ADDENDUM NO. 2

WASTEWATER TREATMENT IMPROVEMENTS PROJECT Morning Sun, Iowa

The Plans and Specifications prepared for this project are hereby modified, amended or clarified as follows:

1. Reinforcing quantities have been re-calculated and updated. Replace the following plan sheets with the attached sheets: F1.1, S1.0-S3.1, S4.0, S5.0, and S6.0. Note: Structures on sheets 2.1 and 2.2 DO NOT include hooks or splice lengths for horizontal reinforcing.

NITROX REACTOR TANKS STRUCTURE PLAN

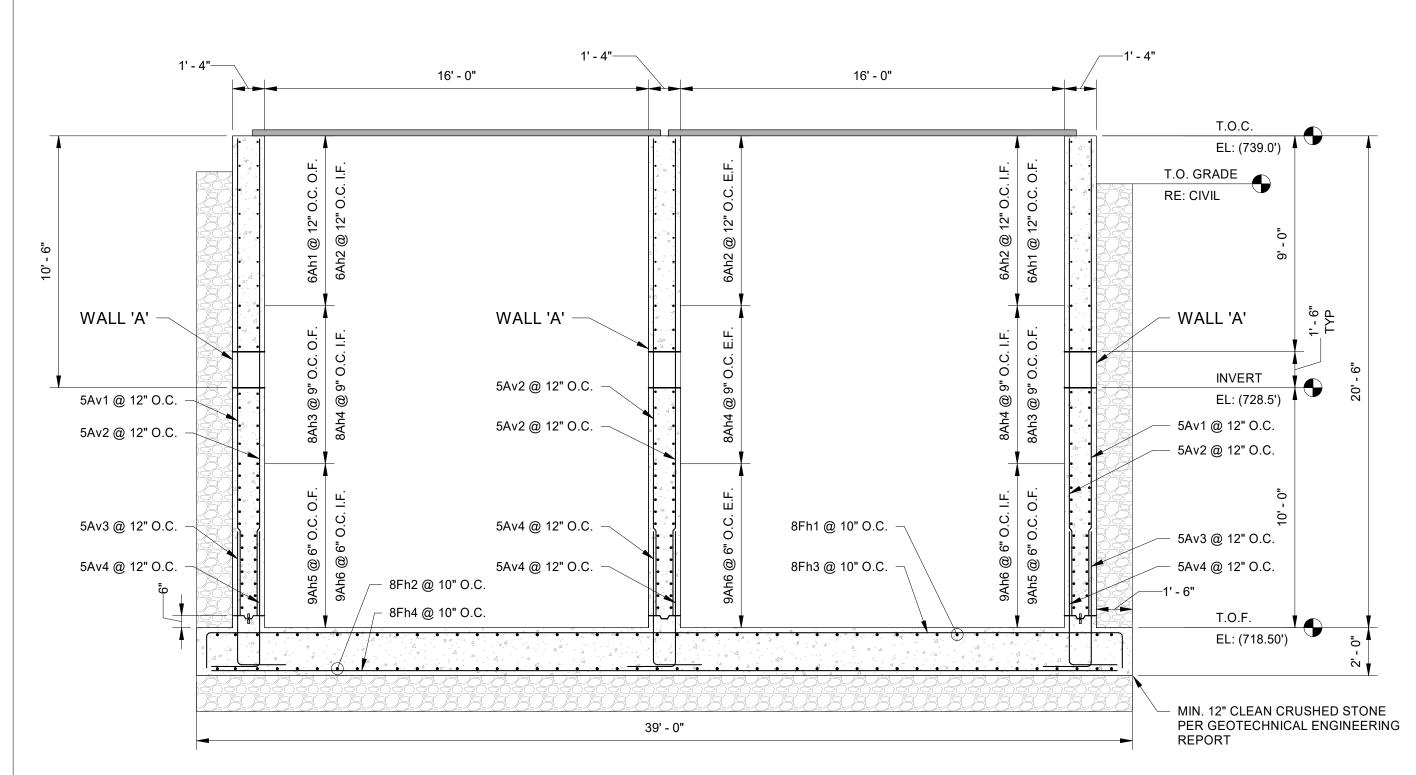
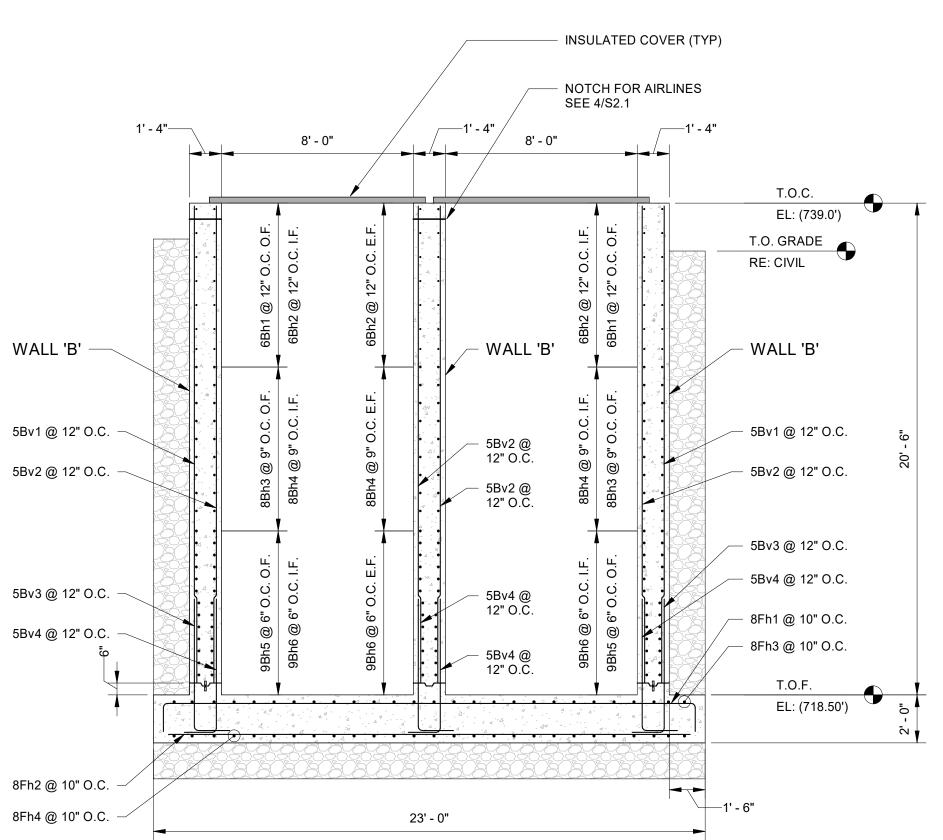
ADDED REINFORCING FOR WALL OPENINGS PER DETAILS 4&5/\$3.0 IS NOT INCLUDED IN THIS TABLE.
 HORIZONTAL BAR LENGTHS ARE BASED ON WALL LENGTH. ADD LENGTHS OF ALL HOOKS AND SPLICES FOR HORIZONTAL REINFORCING TO THIS TABLE.
